ATTACHMENT 3

PROPOSED TECHNICAL SPECIFICATIONS

Marked-up Technical Specifications Pages,

TURKEY POINT UNIT 3 CYCLE 13
CORE OPERATING LIMITS REPORT

~~FIGURE 3-2-1~~

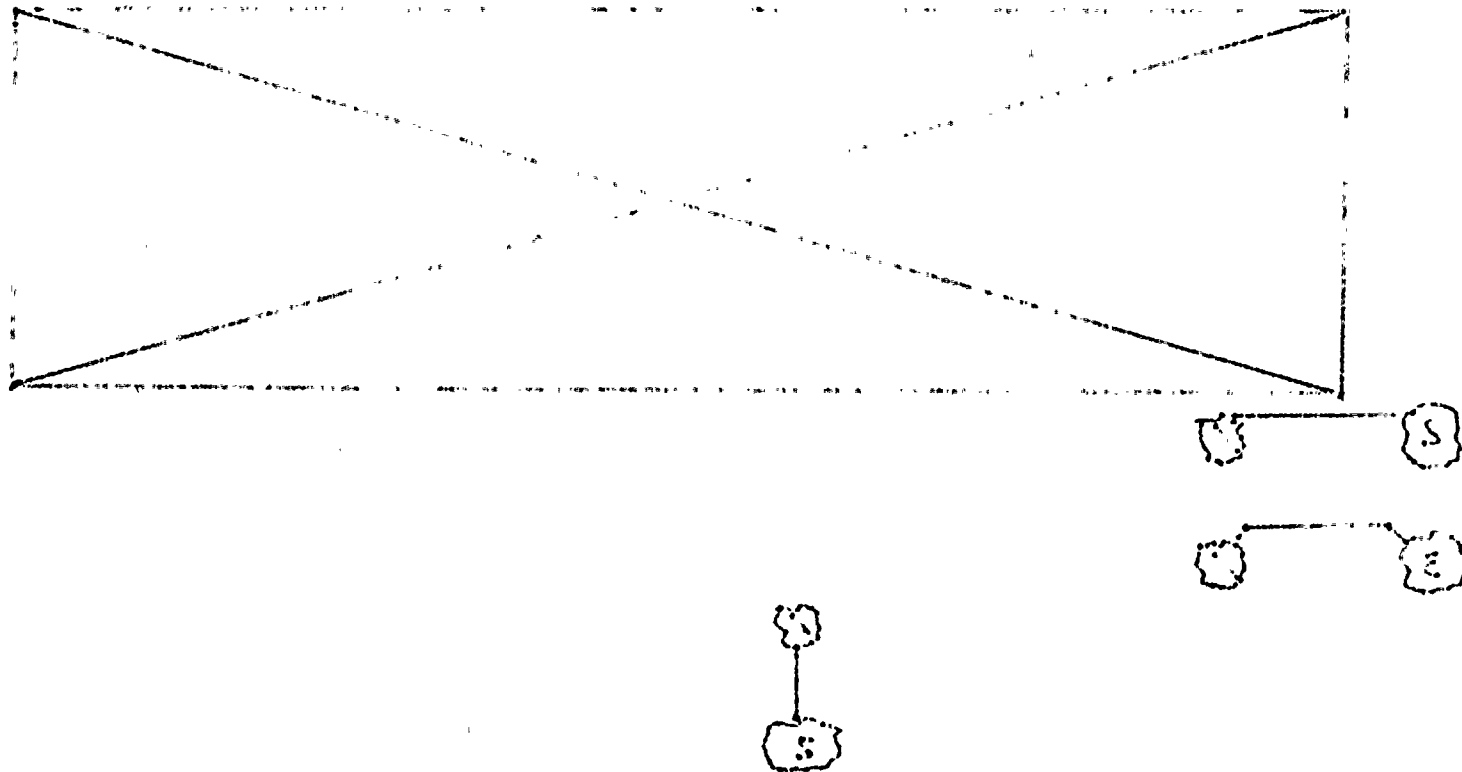
DELETE

~~AXIAL FLUX DIFFERENCE LIMITS AS A FUNCTION OF
RATED THERMAL POWER~~

INSERT 2

3.2.1 The indicated AXIAL FLUX DIFFERENCE (AFD) shall be maintained within:

- a. the allowed Relaxed Axial Offset Control (RAOC) operational space as defined in the CORE OPERATING LIMITS REPORT (COLR), or
- b. within a $\pm 2\%$ or $\pm 3\%$ target band about the target flux difference during Base Load operation.

COLR for Turkey Point Unit 3 Cycle 13

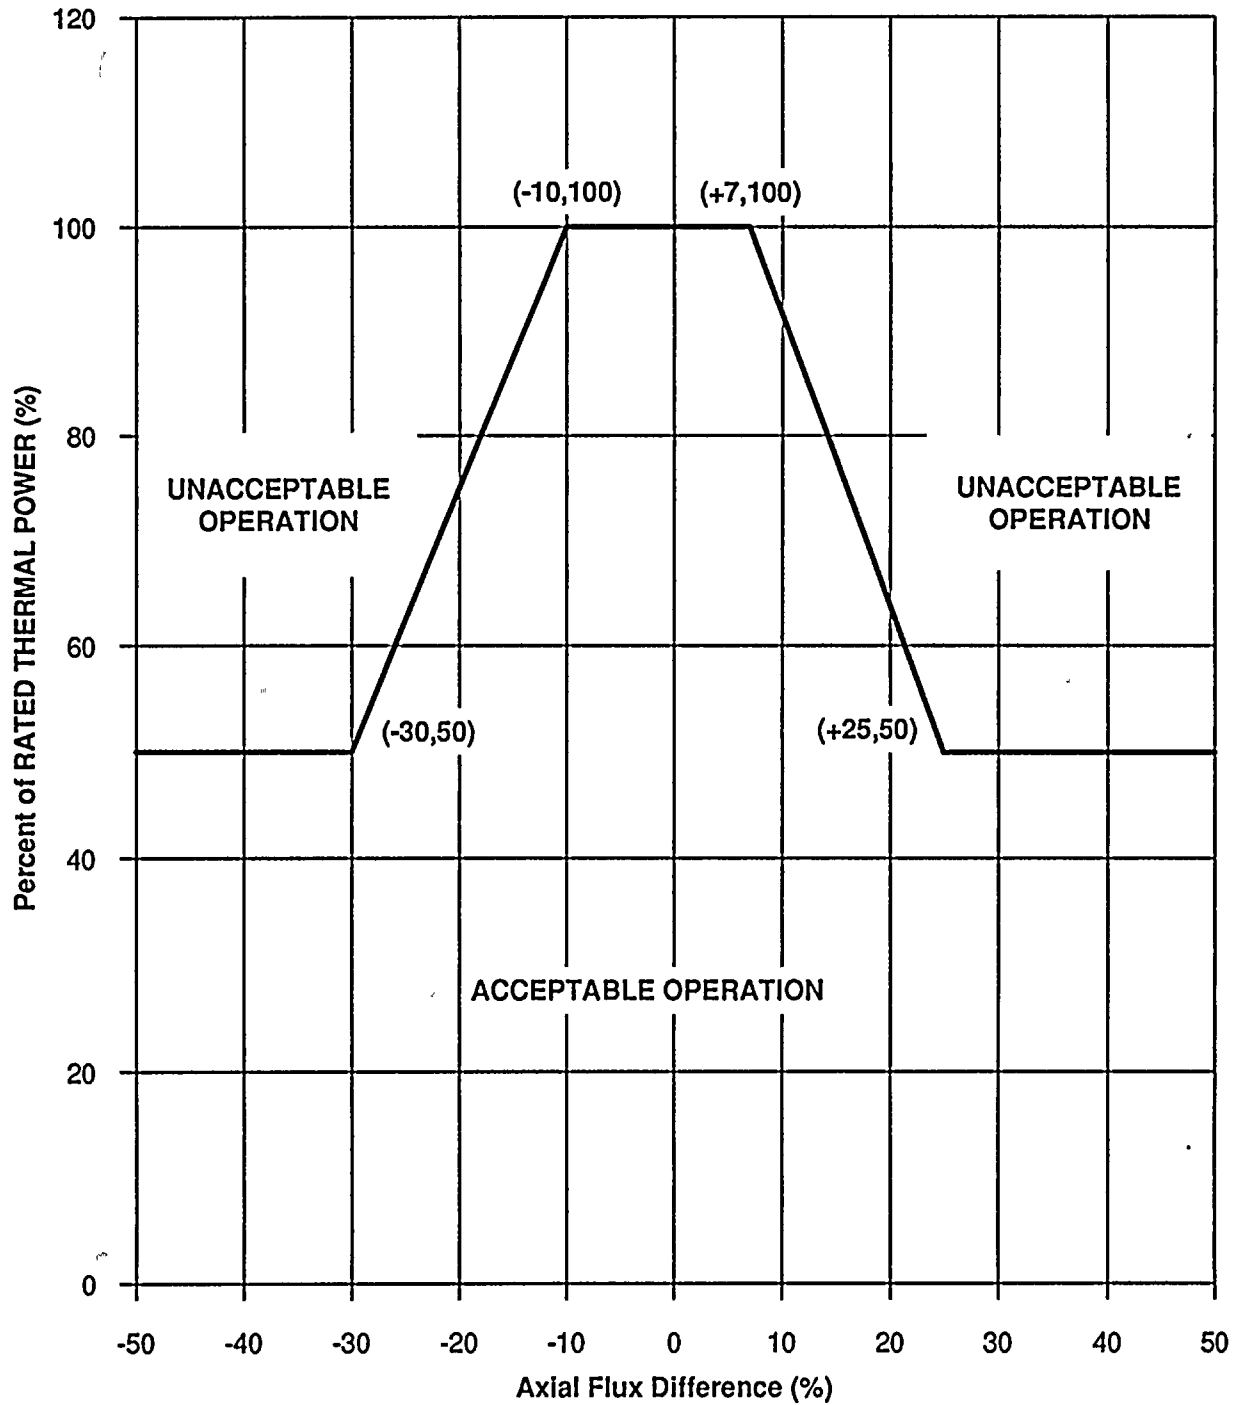
The AFD (RAOC) limits has been developed using the NRC approved methodology specified in Technical Specification 6.9.1.7. The AFD Limits are provided in the attached figure. The RAOC AFD limits were generated assuming a Cycle 13 exposure greater than 6,000 MWD/MTU. Therefore, a note indicating the applicable exposure is included in the attached Figure.

Only applicable after Cycle 13 Exposure of 6,000 MWD/MTU
